**TOTAL MAXIMUM DAILY LOAD (TMDL)**

**UPPER RIO GRANDE WATERSHED (PART 2)**

**COCHITI RESERVOIR TO PILAR, NM**

**June 2, 2005**

**Figure 6.2 Relationship between TSS and Turbidity for the Rio Grande (non-pueblo Santa Clara to Embudo Creek)**

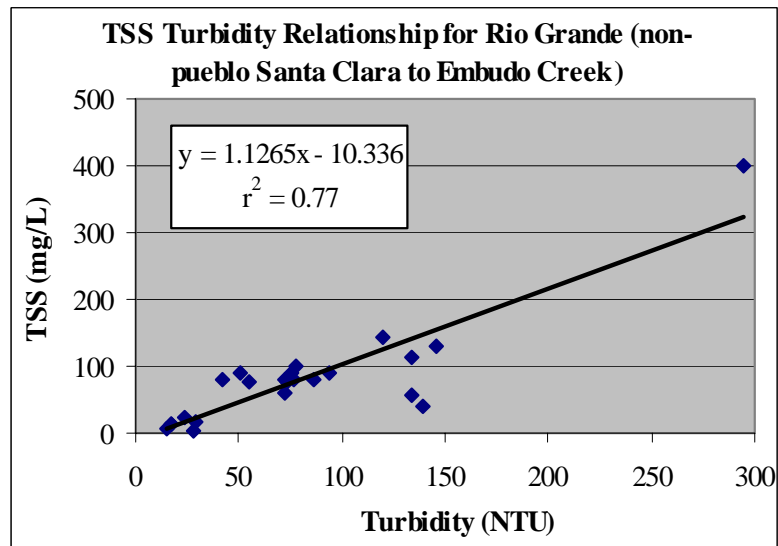
The Draft contains a table showing the total suspended sediment (“TSS”) and the NTUs for the stretch of the Rio Grande area in question. Draft at 6.1 (Table 6.2). Significantly, the table shows the upper Rio Grande exceeding 50 NTU 71% of the time. That fact alone can be seen as dispositive of whether the 50 NTU standard ought to be maintained. If under the natural condition, a norm would be violated three-quarters of the time, it makes little sense to establish the norm at 50 NTU. Suspending the 50 NTU standard would thus represent an acknowledgement of the reality of the natural condition along this stretch of the Rio Grande.

***NMED/SWQB Response: Thank you for commenting. During the February 2004 triennial review of New Mexico's Water Quality Standards, NMED proposed changes to the turbidity standards to recognize varying background conditions. The WQCC approved these recommended changes. NMED is in the process of submitting proposed changes to EPA Region 6 for review and approval. Your comments have been forwarded to the SWQB Water Quality Standards Coordinator.***
